JINDABYNE POLICE STATION

BUILDING CODE OF AUSTRALIA 2019 AMENDMENT 1 REPORT

Report reference 20250R03

| Description | Prepared by | Revision No. | Date |
|---|---------------|--------------|------------|
| BCA 2019 Amendment 1 Report (DA Submission) | Rebecca Kilty | R03 | 19/03/2021 |

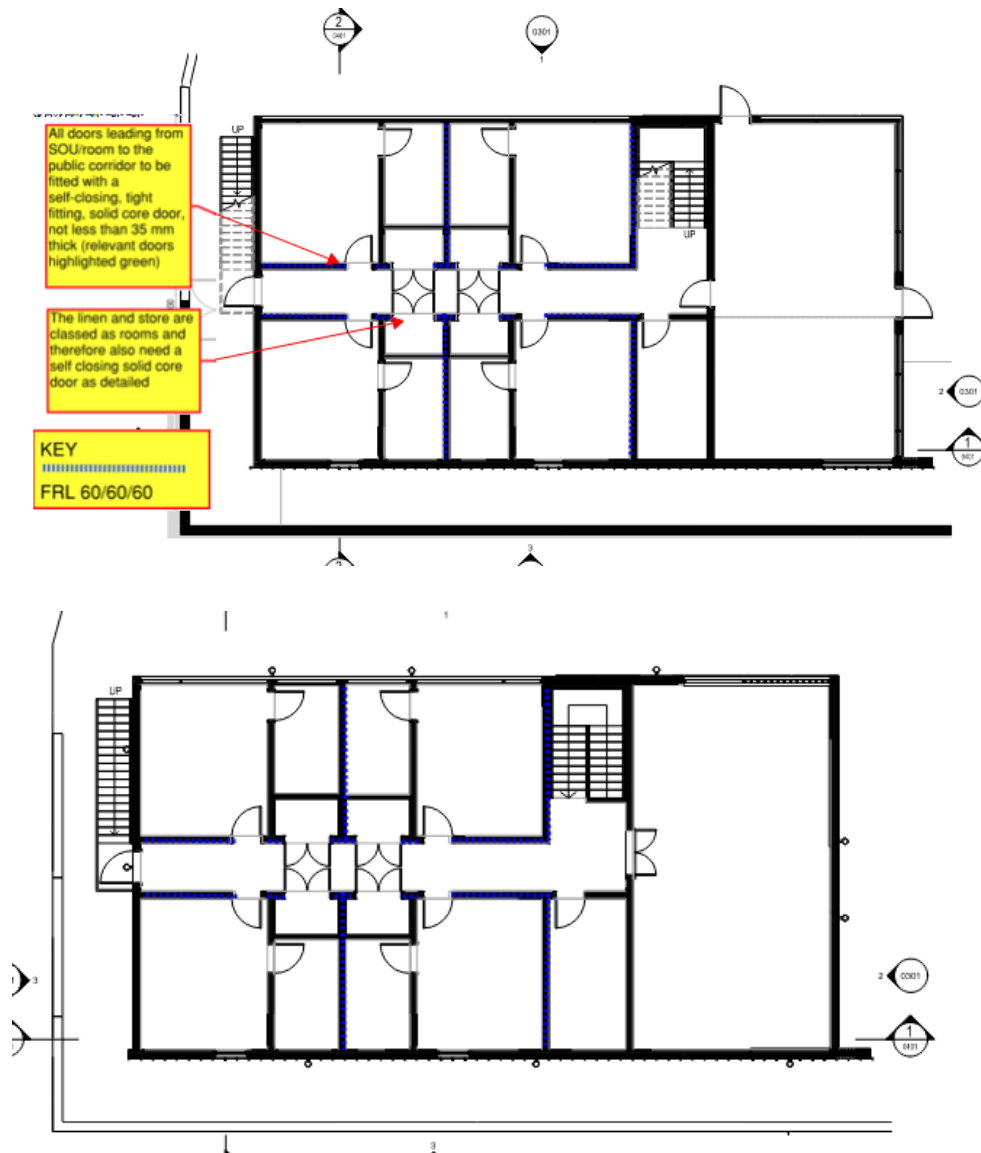
The accommodation rooms are considered to be a sole occupancy unit and the walls bounding the rooms are required to have an FRL of not less than 60/60/60 and must extend:

- *to the underside of the floor next above if that floor has an FRL of at least 30/30/30 or a fire-protective covering on the underside of the floor; or*
- *to the underside of a ceiling having a resistance to the incipient spread of fire to the space above itself of not less than 60 minutes; or*
- *to the underside of the roof covering if it is non-combustible, and except for roof battens with dimensions of 75mm x 50mm or less or sarking-type material, must not be crossed by timber or other combustible building elements; or*
- *450 mm above the roof covering if it is combustible*

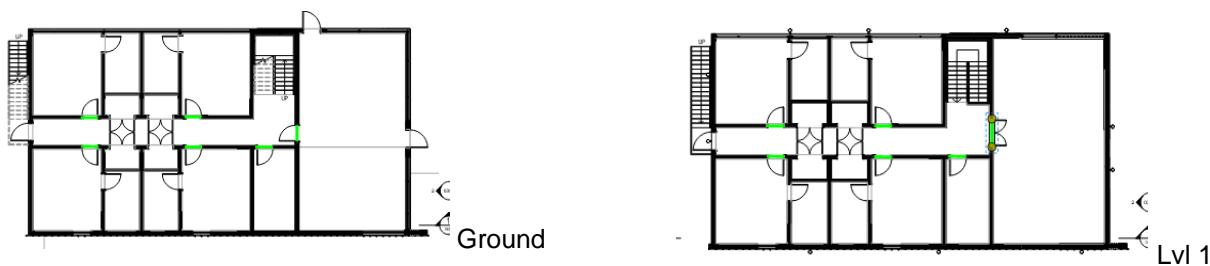
The window in the external wall on the north side of the accommodation building is within 3m of a fire source feature in an external wall that is required to have an FRL. The window is therefore required to be protected in accordance with BCA C3.4. The non-compliance has occurred due to a boundary line which runs through the building. Whilst this is unlikely to cause a safety issue, it is a technical non-compliance with the BCA. This can remain as a technical non-compliance or alternatively can be resolved by consolidating the lots, or it can be addressed by a fire engineered alternative solution. See below mark-up of the external walls which are exposed to the boundary line. See below mark-up of the window which is required to be protected.

If the window is to comply and be protected in accordance with the BCA 2019 amendment 1, it is required to be addressed using one of the following methods detailed in the extraction below from the BCA;

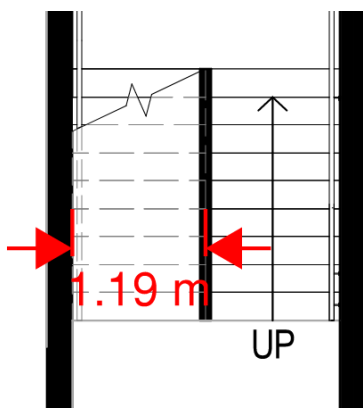
The stair in the Police station building leading to from level 1 to ground is currently shown as 1.12m. The stair does not show the handrail measurements. It should be noted during the preparation of the design documents that a 1m clearance between the handrails for the path of travel should be retained.

The stair in the accommodation building leading to from level 1 to ground is currently shown as 1.19m. The stair does not show the handrail measurements. It should be noted during the preparation of the design documents that a 1m clearance between the handrails for the path of travel should be retained.
